# SERVICE BULLETIN

**Bulletin No.** SVB-113

**Model** 125/5 Engine

**Subject** Port Timing Modification-Racing

PORT TIMING MODIFICATION FOR INDIAN 125/5 ENGINE  
( FOR RACING ONLY )  
55MM X 52MM

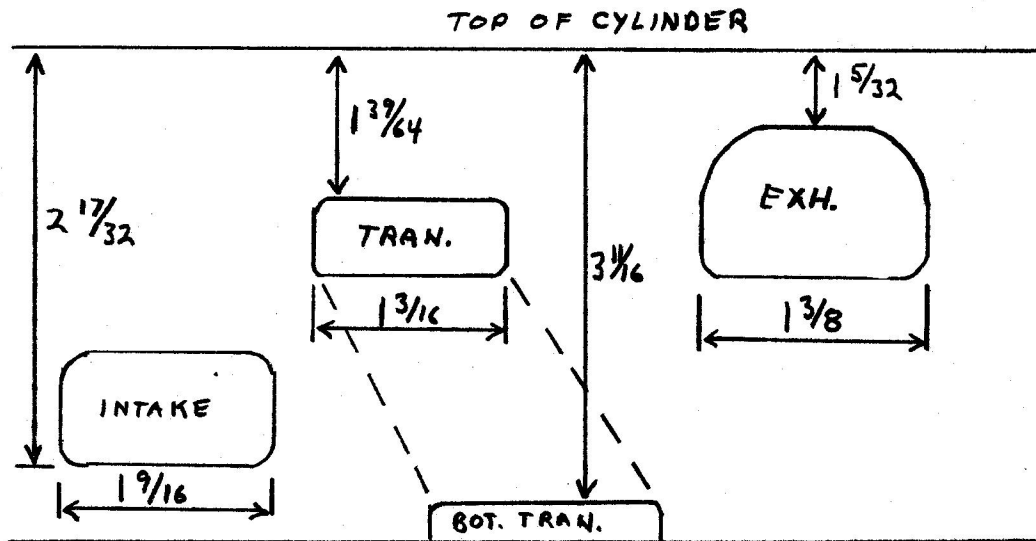
NOTE: MILL THE STOCK HEAD .060

SET ING. TIMING AT 2.1 MM B.T.D.C.
